LiDAR Quality Assessment Report

Municipality of Anchorage Lidar Mapping

Project: Municipality of Anchorage Lidar Mapping

Contractor: Merrick

Checkpoint Distribution Image

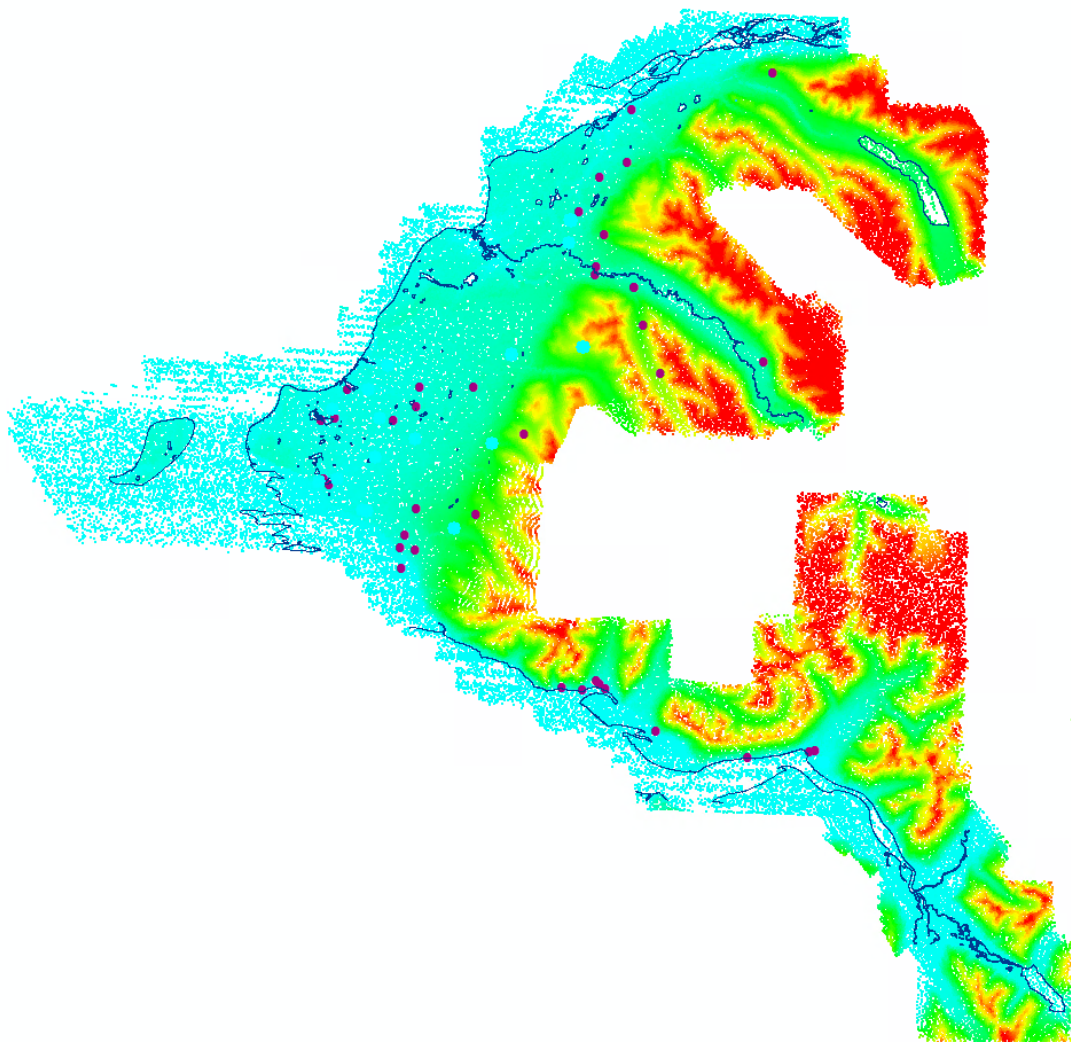
Checkpoints are well distributed? ☒

Enough checkpoints for task order? ☒

Checkpoints meet USGS LiDAR base-spec in quantity and quality? ☒

<i>Reviewed Unit:</i>	<input type="text" value="Meters"/>
<i>Reviewed # of checkpoints:</i>	<input type="text" value="55"/>
<i>Reviewed RMSEz:</i>	<input type="text" value=".076"/>
<i>Reviewed Vertical Accuracy (RMSEz * 95th CI)</i>	<input type="text" value="0.149"/>

<i>Reviewed Unit:</i>	<input type="text" value="Meters"/>
<i>Reviewed # of checkpoints:</i>	<input type="text" value="55"/>
<i>Reviewed RMSEz:</i>	<input type="text" value=".077"/>
<i>Reviewed Vertical Accuracy (RMSEz * 95th CI)</i>	<input type="text" value="0.151"/>

<i>Required Unit:</i>	<input type="text" value="Meters"/>
<i>Required # of checkpoints:</i>	<input type="text" value="45"/>
<i>Reviewed Vertical Accuracy (95th percentile)</i>	<input type="text" value="0.176"/>

Based on this review, the USGS accepts the vertical accuracy.
